## **URGENT Field Safety Notice**

### **ABL90 FLEX and ABL90 FLEX PLUS**

#### **– Risk of incorrect time and potentially biased results**

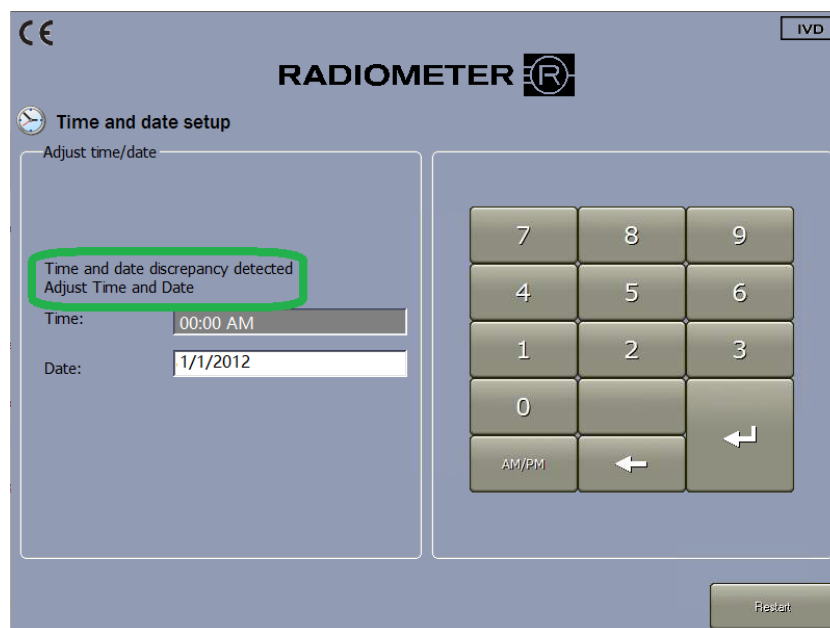
The software update ensures that the analyzer will detect any date and time discrepancy that may appear during a startup following an abrupt power break.

When detected the analyzer will:

- Reset the date to 1/1/2012 and time to 00:00 (or earlier) and start running from there.
- Display the following screen prompt prior to full startup:

*Time and date discrepancy detected  
Adjust Time and Date*

- The operator must then adjust time and date and touch Restart to confirm and restart the analyzer.

If the analyzer shows the above screen during startup then adjust the time and date.
